Deadline 5 Submission:

**Application by Tritax Symmetry (Hinckley) Limited for an
Order Granting Development Consent for the Hinckley
National Rail Freight Interchange**

(ref. TR050007)

Document and Section Reference	Hinckley & Bosworth Borough Council Response
---------------------------------------	---

AM peak Typical Google Maps Delays – 2024 existing (Google maps Traffic data)

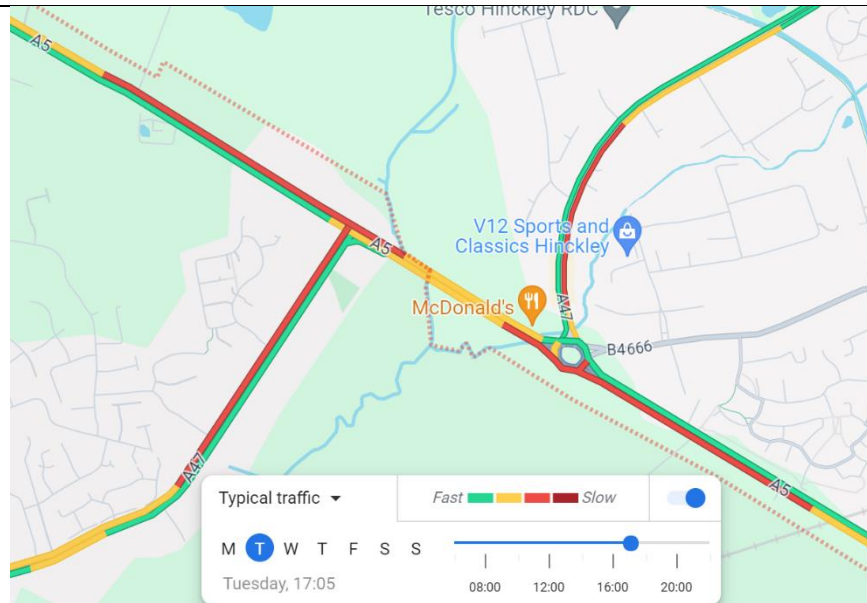
<p>A5/A47/B4666 roundabout junction (and related A5/A47 Longshoot signal junction) and M69 Junction 3 (junction with A5)</p>	<p>The operation of these junctions on the second key strategic route in the borough of the A5 (the M69 above is the other one) remains a significant concern for HBBC – problems here lead to vehicles re-routing through Hinckley. The applicant is proposing no mitigation, and the day-to-day existing conditions here include significant delays and queuing, even outside of the peak hours. It this is exacerbated there will pressure to divert from the strategic network to other local roads with consequent problems. The Google traffic plans below show existing conditions, with congestion also being experienced between the peak hours.</p>

The modelling and assessment of these junctions has not yet been accepted by the highway authorities and until this is the case, there is doubt over the conclusions. HBBC notes that at present all site HGVs from the A5 use the A47 to the link road to the site (rather than the A5/M69 route) in the morning peak and representations have been made to designate this route an Undesirable Road in the HGV strategy; this will impact all of the junction assessments along this stretch of the A5.

Extract from plans for Normandy Fields 850-unit development north of A47 - 15/00188/OUT

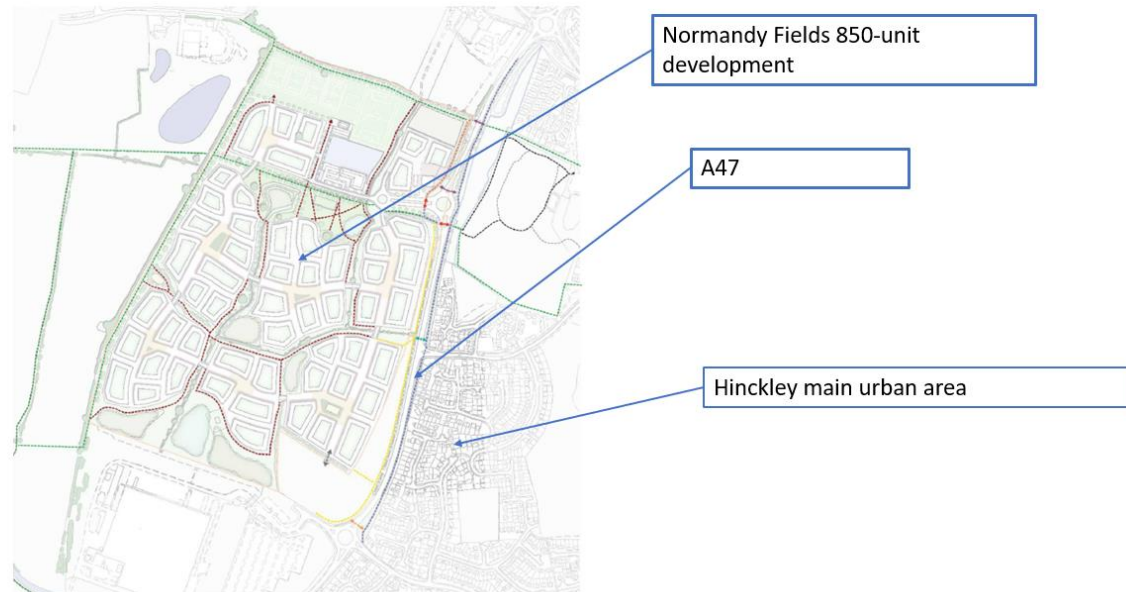
While the A47 is an A road, the western part of it is 30 mph, it has a walk/cycle route along it, and it forms a barrier between the growing areas of the borough and the existing built-up area. One example is the development being constructed as Normandy Fields (15/00188/OUT, see extract of site plan below). This shows clear pedestrian /cycle linkages across the A47 between future and existing development and facilities such as primary and secondary schools, the town centre etc. While there will be controlled pedestrian crossings of the A47, it is clearly desirable to reduce the extent of HGV use of the A47 where possible; this will also help reduce any undesirable HGV parking problems, which are a key concern of HBBC residents.

There will be much higher demand for pedestrians and cyclists crossing it over time, and experience shows that there will be pressure to downgrade this type of road, reduce speed limits and make it less traffic dominated; in other words, development has 'leap-frogged' a traffic-focused road and this needs to change in nature.

- 3) The A47 will still be used by existing HGVs and some attracted to the use of the new link road, but removing the use of the A47 for all HGVs associated with the development (with the exception of local access or high-sided vehicles until the A5 low-height bridge is mitigated) will help mitigate HGV impact on the HBBC area by HGVs. This is very feasible to enforce using the applicants HGV management strategy. It will require the vast majority of the HRNFI HGV:S to use the A5 and M69, which are the appropriate strategic roads, as set out by the applicant in Figure 3.

Consequently HBBC requests that the HGV Management Strategy be amended in para 3.14 and Figure 4 to show the A47 between the A5 and the B4668 (Leicester Road) and the B4668 between the link road and the A47 as being a 'prohibited road' with appropriate enforcement.

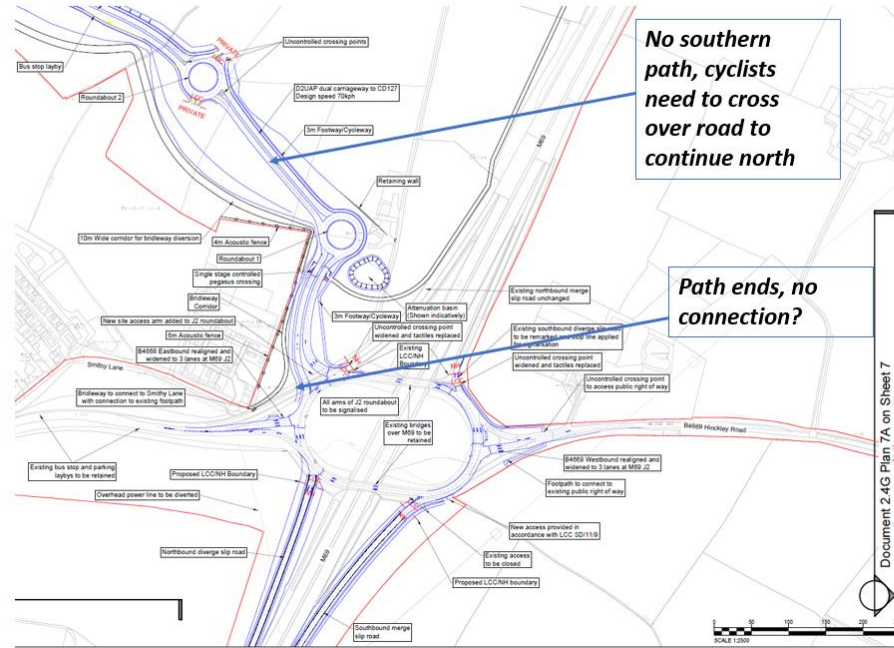
The applicant has analysed a number of further cycling improvements but has only proposed 3 of these:

- Option 1 – Enhancement to Barwell, Toucan crossing on A47-
- Option 2 - Enhancement to Barwell, Gateway at The Common
- Option 8 – Enhancement to Hinckley and Burbage, New Cycle Lane to the B4669 between Smithy Lane and Wilkinson Avenue.

HBBC note that there is some confusion in the STS between 'options' and 'enhancements' for example option 1 in 8.20 seems to be enhancement 8 in Figure 17.

Highway Plans Sheet 4 extract – 2.4D

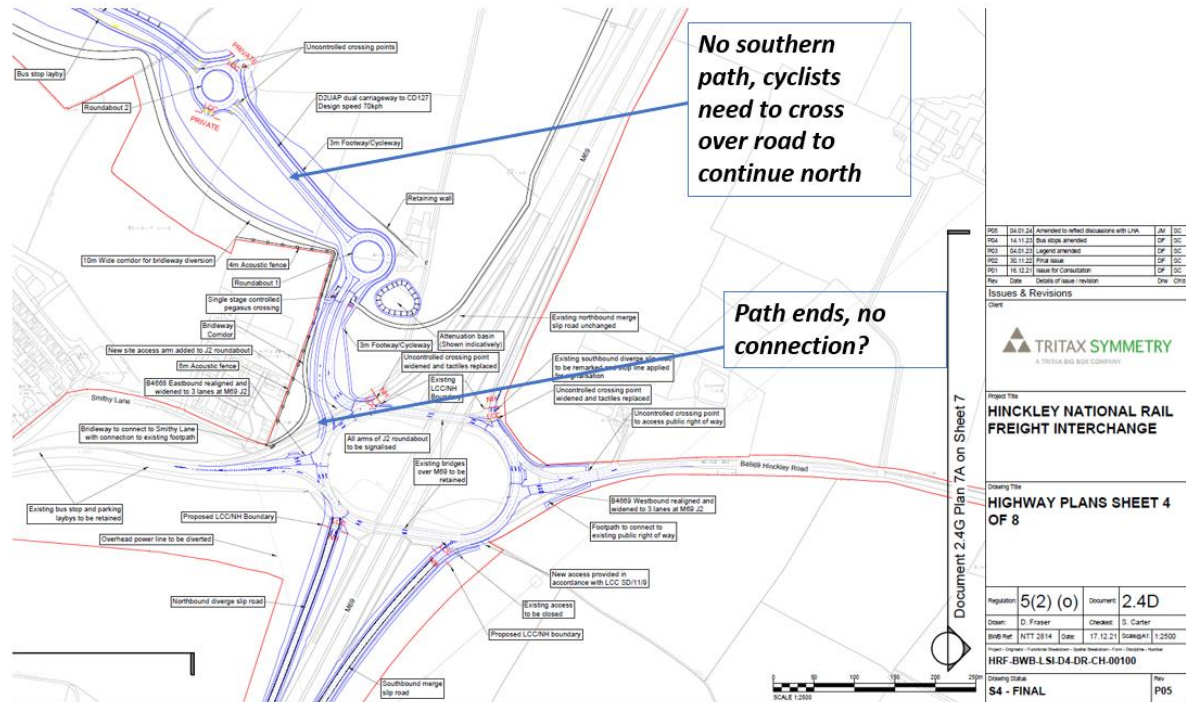
2. The provision of shared use facilities on the new link road is welcome, but they appear to fall short of the direct and continuous requirements in LTN1/20, as in one case the facilities appear to end without a connection (sheet 4) and the users of this path have to cross the road in 2 locations to continue in a north/south direction (sheets 1 and 4) – see highway plans below. **Consideration should be given to a continuous cycle route in a north/south direction adjacent to the link road.**

No southern path, cyclists need to cross over road to continue north

Path ends, no connection?
